Access Compliance Report Public Rights-of-Way (RR Crossings)

Intersection ID: 12613	Main Street: E_TRADE_ST	Location: N/A
ADA ID: FEF74A6F8981	Overall Compliance: No	Severity Score: 0.0
Codes/Mitigation Info/Possible Solution		Field Measurements/Component Compliance

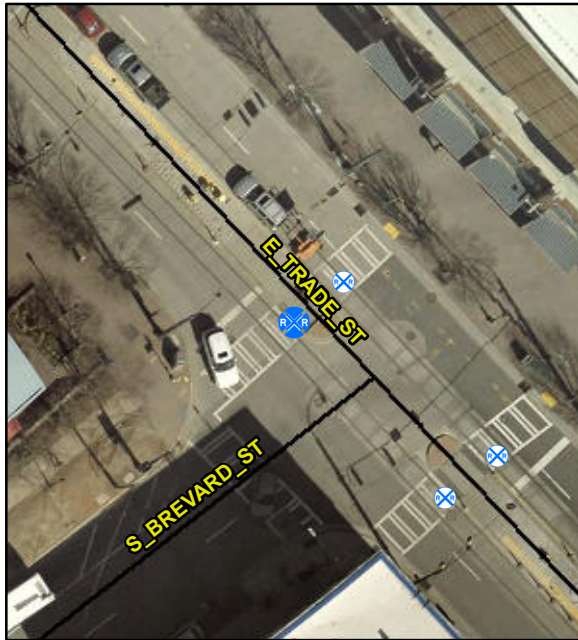
Compliance	Description	Data
Yes	DWS Provided?	Yes
Yes	DWS Contrast?	Yes
Yes	DWS Width (in)	Yes
Yes	DWS Length (in)	24.0
No	DWS Offset (in)	18.5
No	Pedestrian Gate?	No
N/A	DWS Outside Gate?	Yes
N/A	Rail Type?	LightRail
No	Flangeway Gap (in)	2.5
Yes	Sidewalk Width (in)	120.0

**Remove & Replace Detectable
Warning System. Provide Pedestrian
Gate. Remove & Replace Walking
Surface Adjacent to Rail.**
